Re: Terminal Building Remodel & Expansion  
Aberdeen Regional Airport  
Aberdeen, South Dakota  
A.I.P. #3-46-0001-055-2025  
A-9799

**ADDENDUM NUMBER 1**

ADDENDUM NO. 1  
TO GENERAL, MECHANICAL AND ELECTRICAL  
ABERDEEN REGIONAL AIRPORT  
TERMINAL BUILDING REMODEL & EXPANSION  
ABERDEEN, SOUTH DAKOTA

**Date:** May 16, 2025**Project:** Aberdeen Regional Airport Baggage Addition**To:** Dean Marske, AIA  
HKG Architects**Project #:** BS25017**From:** Jon Kennedy, PE  
Stu Oster, PE**Project Location:** Aberdeen, SD**Addendum Number:** No. 1

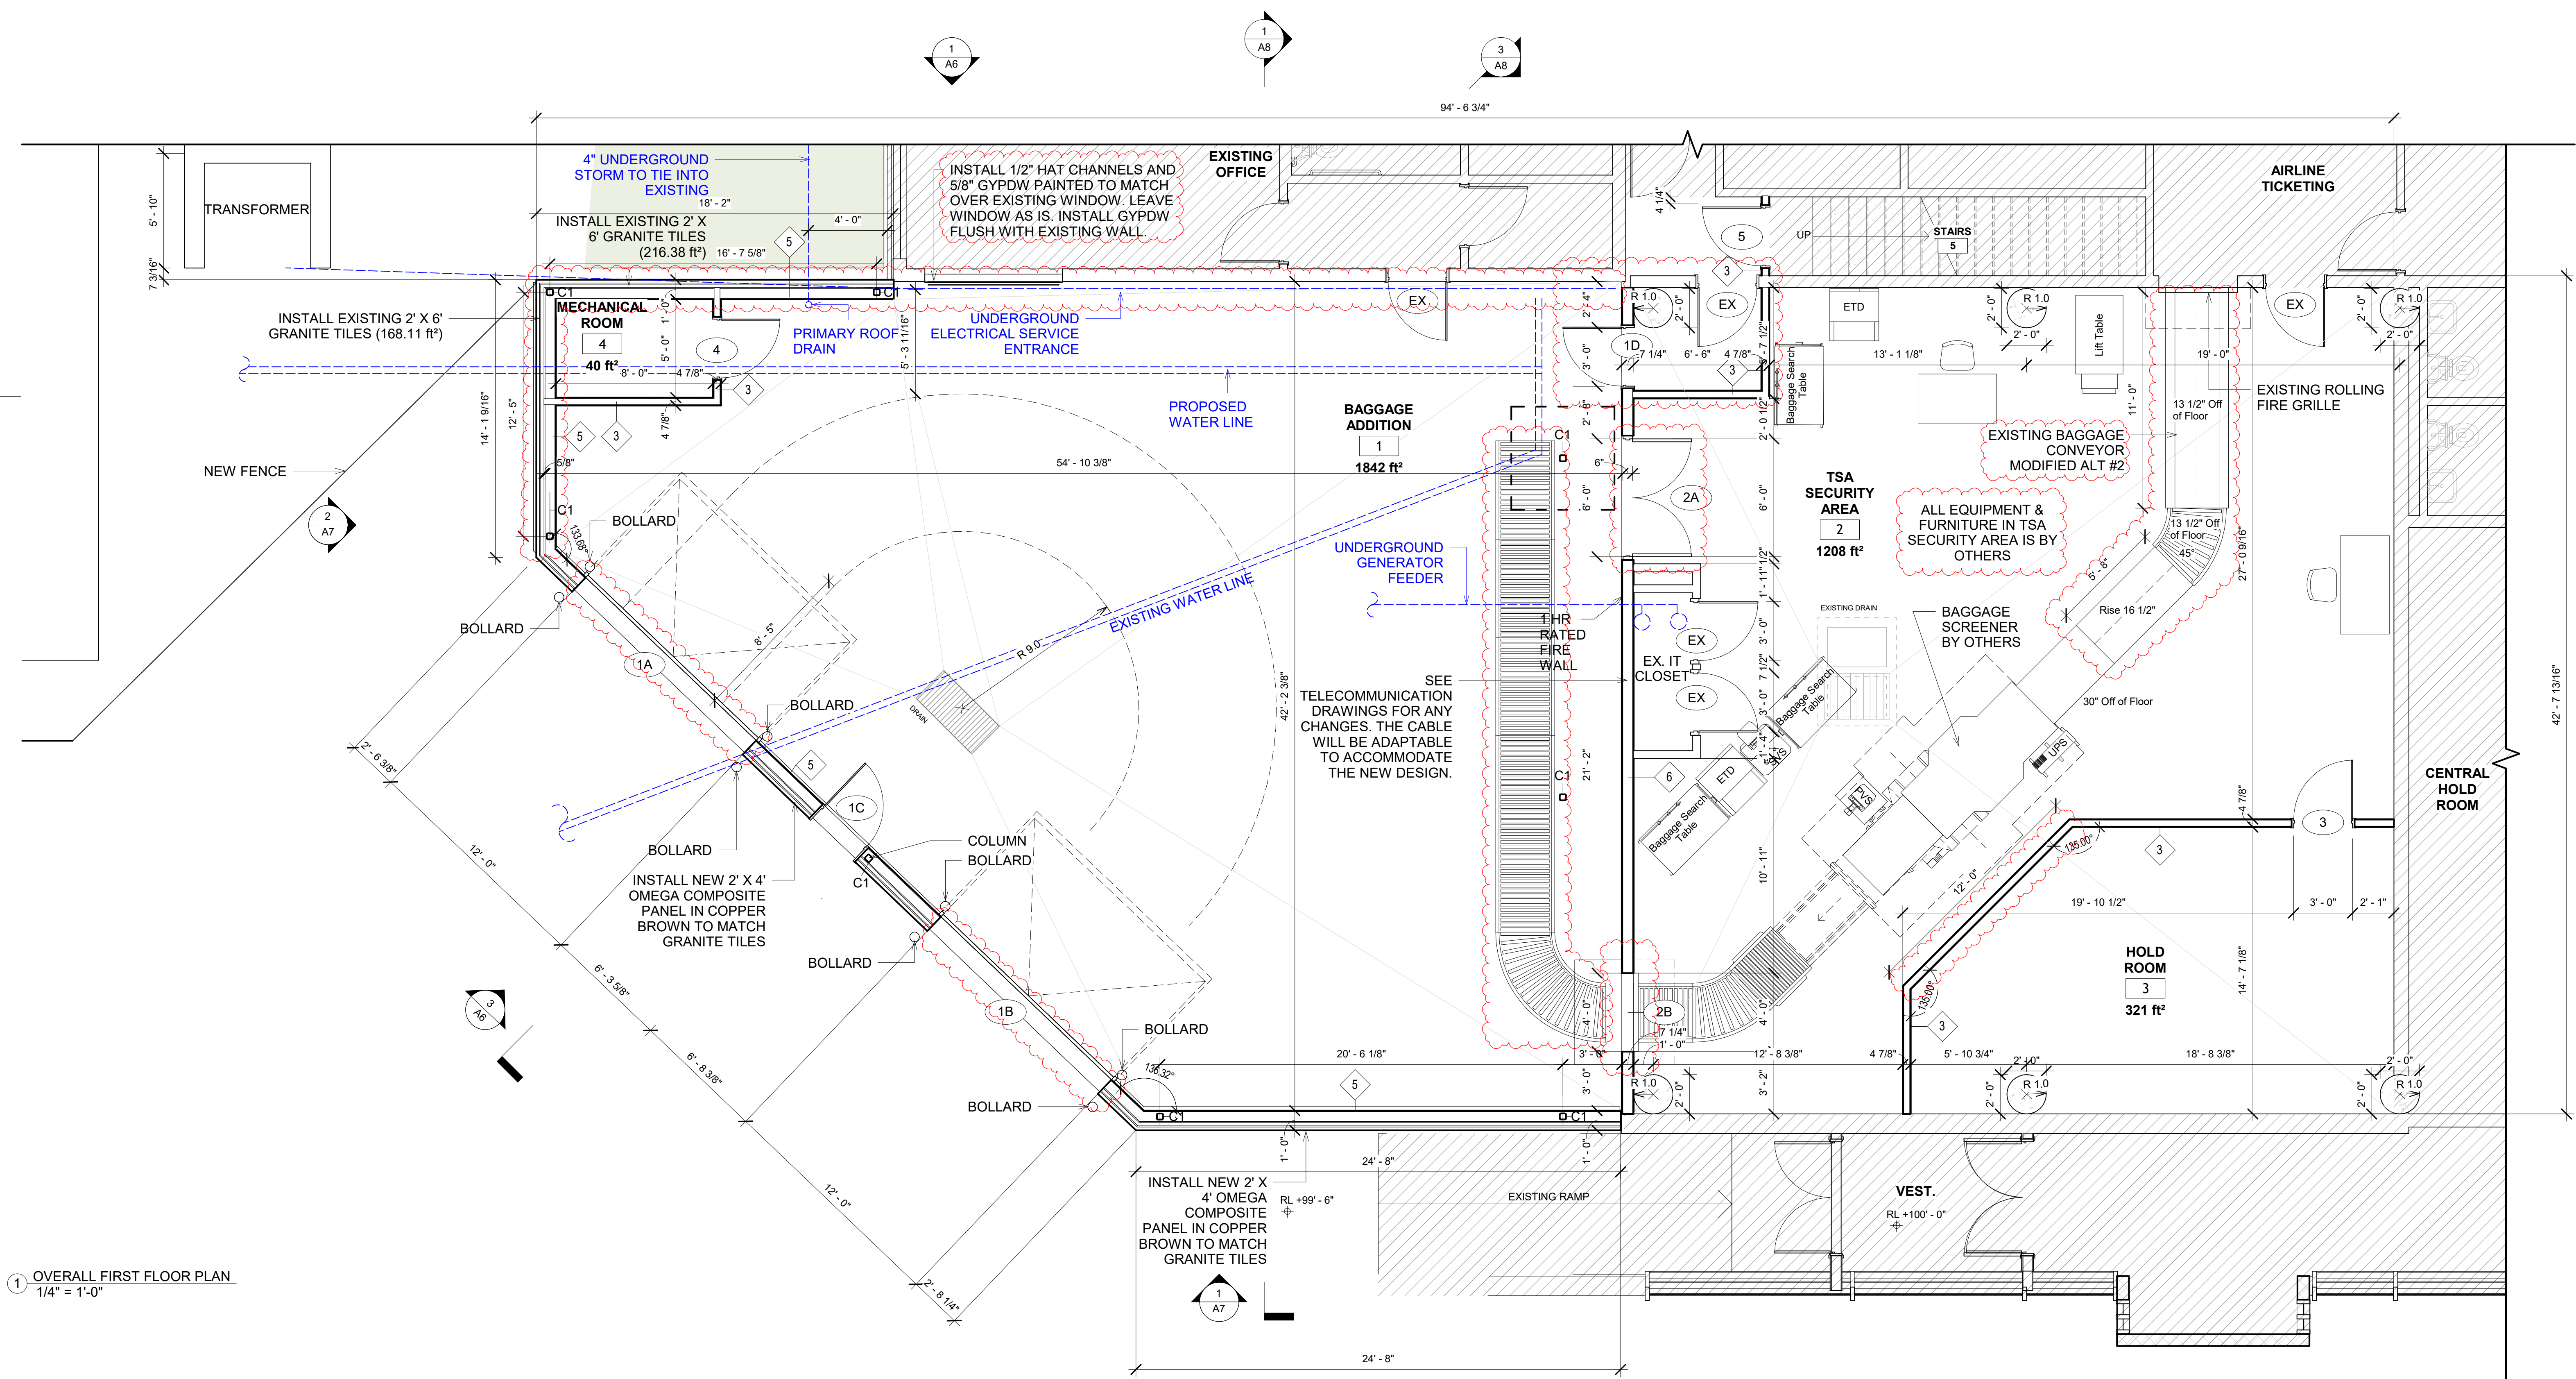
Roller Conveyor, Baggage Addition 1 shall be:

- 2 x B897201 – Ashland 36”W Gravity Roller Conveyor, 10’L, 1.9” Roller Diameter, 4 ½” Roller Centers
- 1 x B897219 – Ashland 36”W Gravity Roller Conveyor, 5’L, 1.9” Roller Diameter, 3” Roller Centers
- 8 x B730135 – H-Stand Support 34511 for Ashland 36” BF Roller Conveyor – 19 ½” to 31” H
- 1 x B897235 – Ashland 90° Curve Roller Conveyor – 36” F – 1.9” Roller Dia. – 3” Axles – 30” Inside Radius
- 1 x 293189 – Global Industrial™ 24” Angle End Stop & Hardware for Roller Conveyors, 12 Gauge Steel
- 1 x B2184914 Ashland Guard Pair 30224 – Galvanized Steel 90 Degree Curve 16” BF 36” Inside Radius

REVISION DATE 5/16/25	Plans for Aberdeen Regional Airport Terminal Building Aberdeen, South Dakota	GROUND FLOOR PLAN	DRAWN BY: EXHIBIT CHECKED BY: DM DATE 4/29/25	PROJECT NO. 2024-0024
	HKG Architects, Inc.	Aberdeen, S.D.

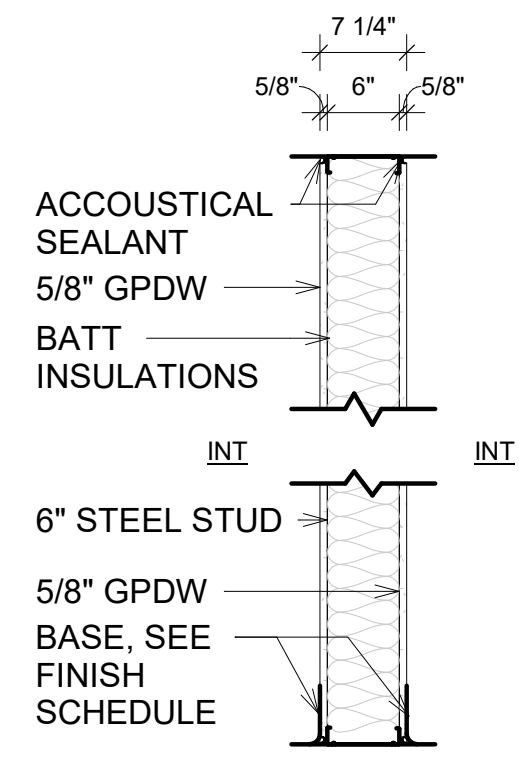
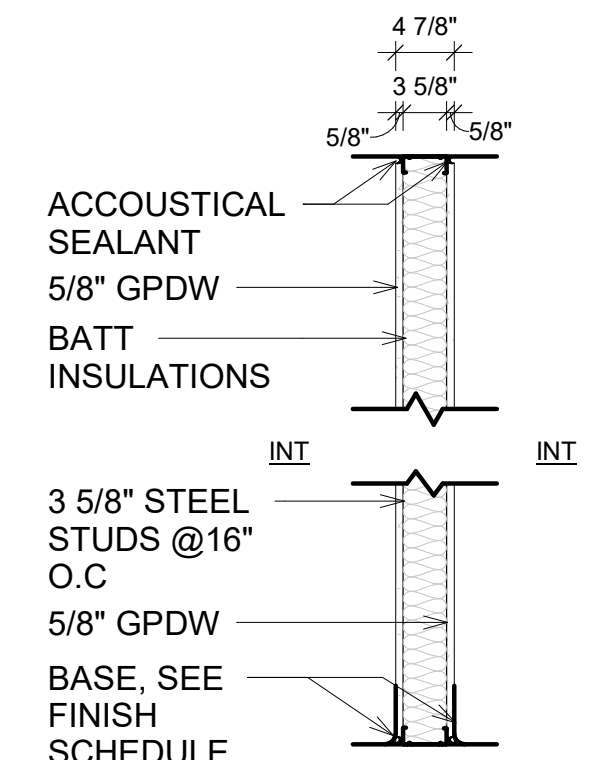
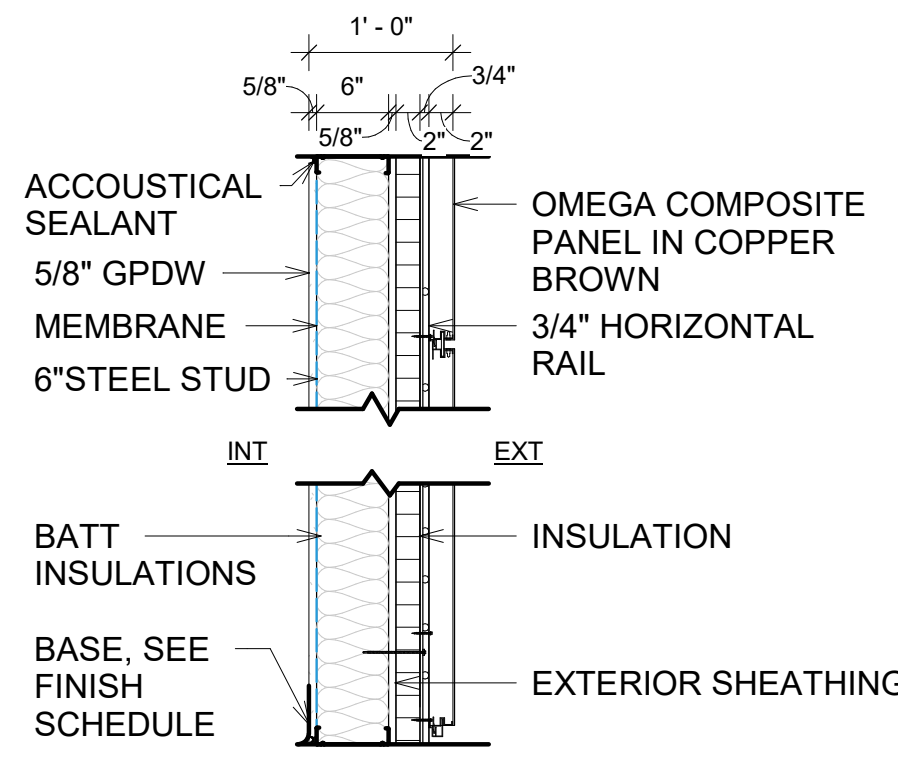
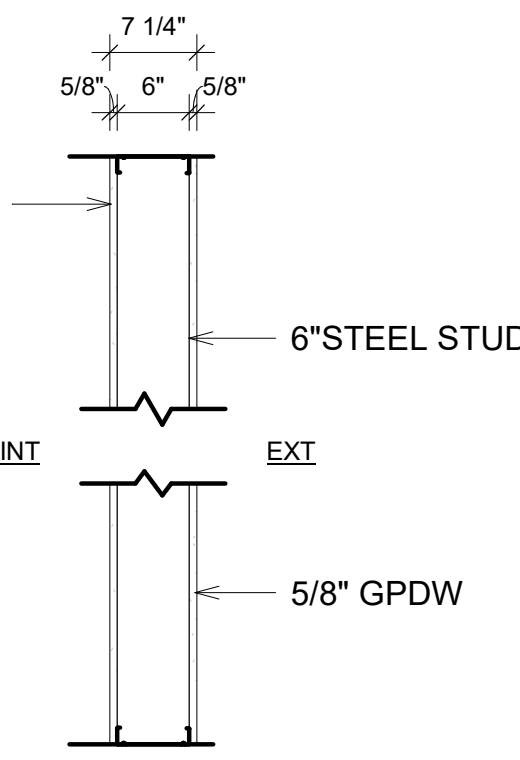
2. Sheet A4:

- a) Delete Page A4 and Replace with Attached Page A4. Changes are as Noted:
  - I) W1 Wall Type was Deleted.
  - II) W4 Wall Type was Deleted.
  - II) Replace W4 Walls with W5 Wall Type Walls.
  - III) Vestibule Containing Doors 1D & EX has been reduced.
  - IV) Door 1D has been Moved and Flipped.
  - V) Door 2A has been Moved Further North.
  - VI) Door 2B has been Moved Further South.
  - VII) TSA Security Area Room 2, Equipment is now shown. All

Equipment is by Others and is not Installed by the Contractor.

VIII) Hold Room 3 has been Reduced.

IX) Install 1/2" Hat Channels and 5/8" Sheetrock, Painted to Match over Existing Window. Leave Existing Window as is. Install Sheetrock Flush with Existing Wall.

X) Include Add Alternate #2; Modify Existing Airport Conveyor.

① SOUTHEAST ELEVATION  
1/4" = 1'-0"

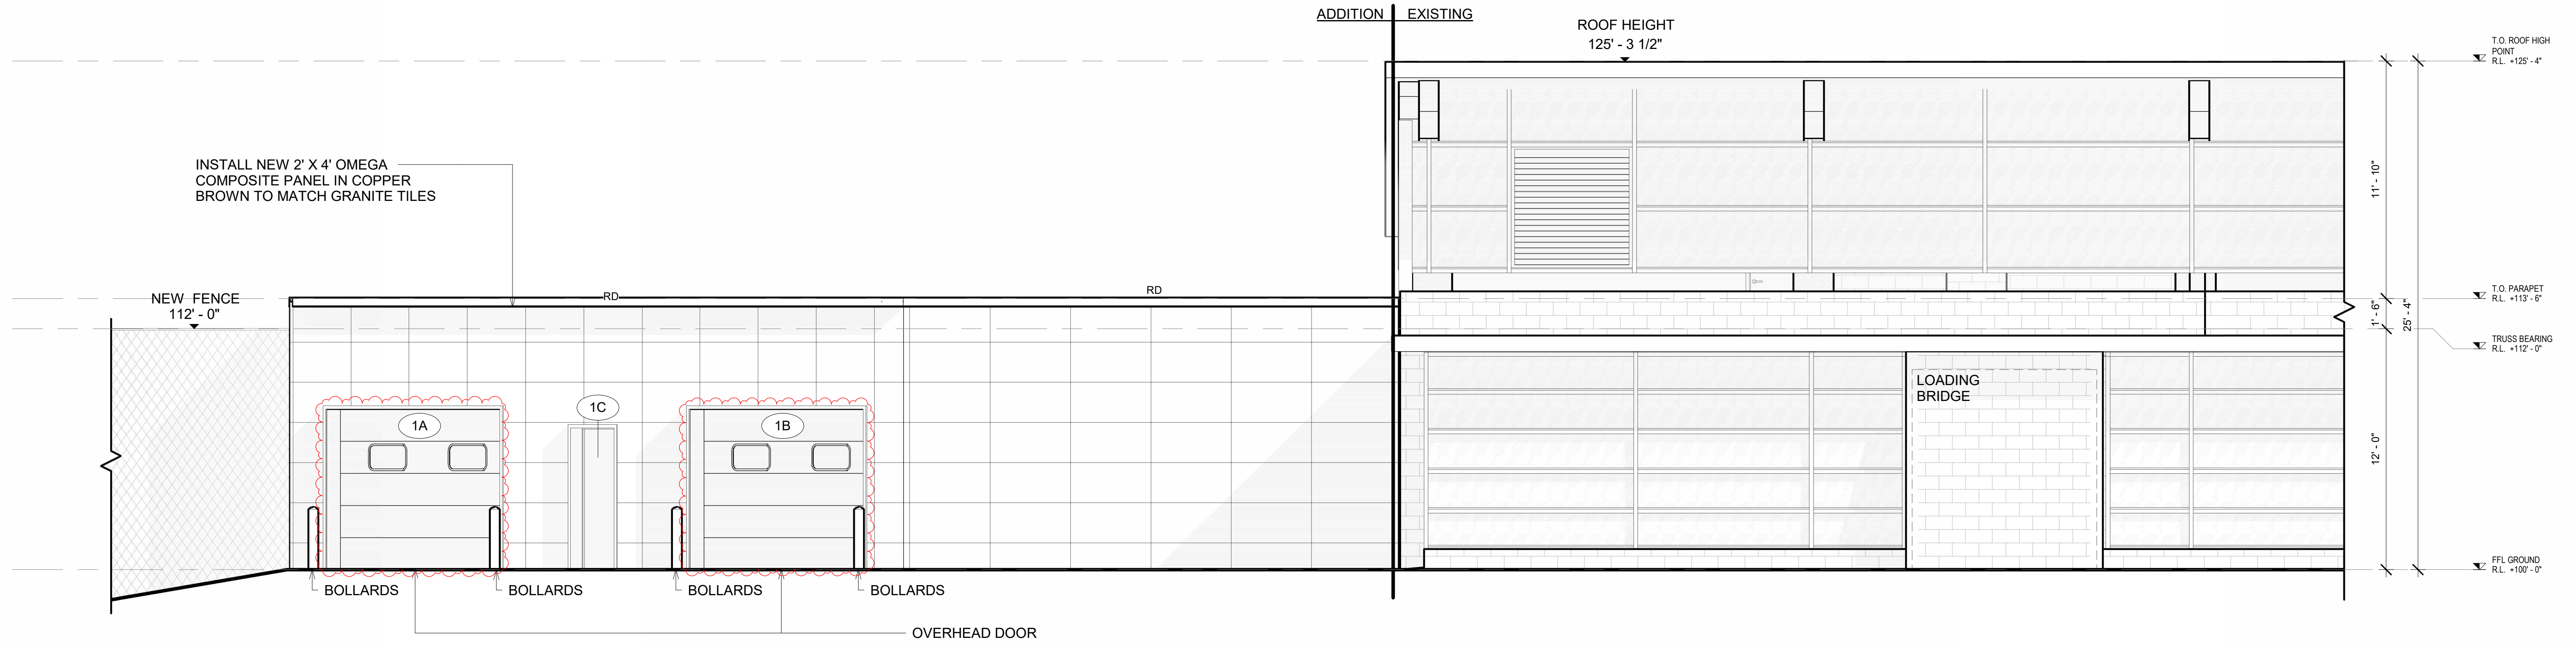
3. Sheet A6:

a) Delete Page A6 and Replace with Attached Page A6. Changes are as Noted:

I) Delete 10'-0" x 8'-0" Overhead Doors and Replace with 12'-0" x 8'-0" Overhead Doors.

II) Delete W4 Wall Type and Replace with W5 Wall Type

② NORTHWEST ELEVATION 2  
1/4" = 1'-0"

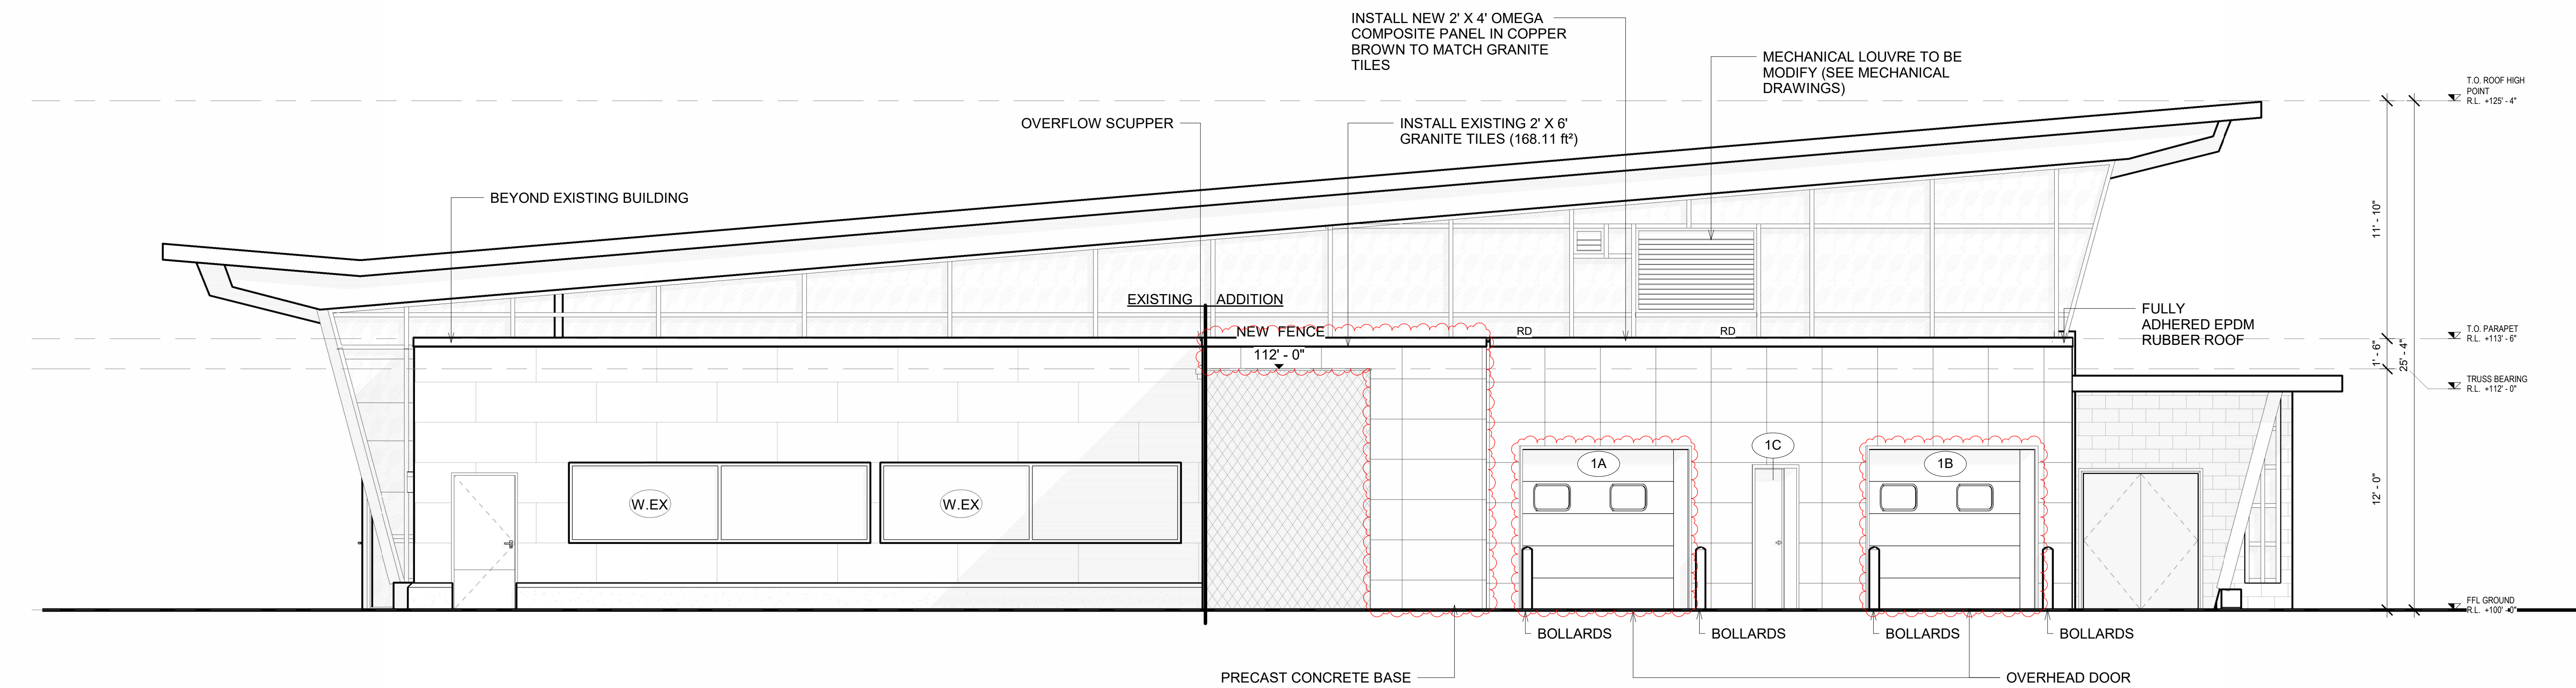
4. Sheet A7:

a) Delete Page A7 and Replace with Attached Page A7. Changes are as Noted:

I) Delete 10'-0" x 8'-0" Overhead Doors and Replace with 12'-0" x 8'-0" Overhead Doors.

II) Delete W4 Wall Type and Replace with W5 Wall Type

### Sheet M4 – Plumbing and HVAC Piping Plan – First Floor

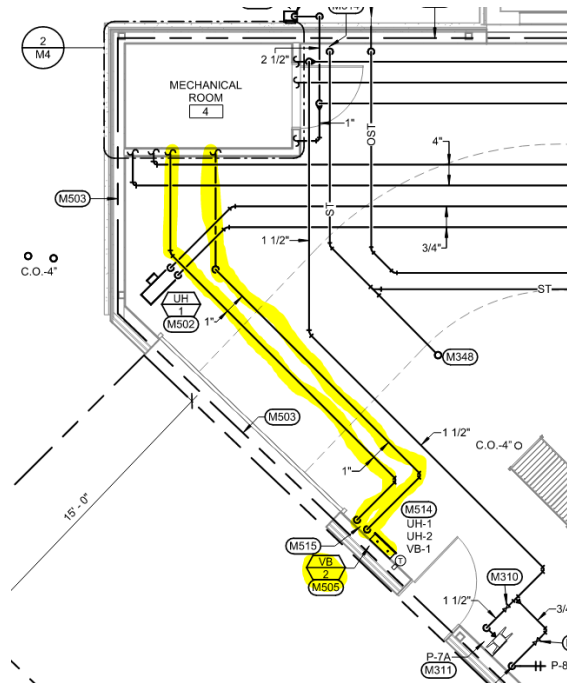
1. Highlighted piping and valve manifold box indicated for new snowmelt system to be provided under scope of Alternate Bid B1 only:

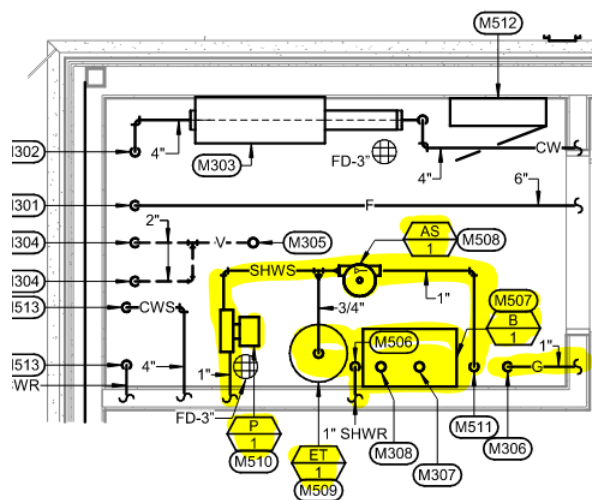
2. Highlighted piping and equipment indicated for new snowmelt system to be provided under scope of Alternate Bid B1 only:

3. VB-1 and VB-2 do not match on floor plans versus the schedule on sheet M12. The schedule on sheet M12 will remain the same for numbering. On sheet M4, switch the VB numbers so that current VB-2 becomes VB-1 and current VB-1 becomes VB-2.
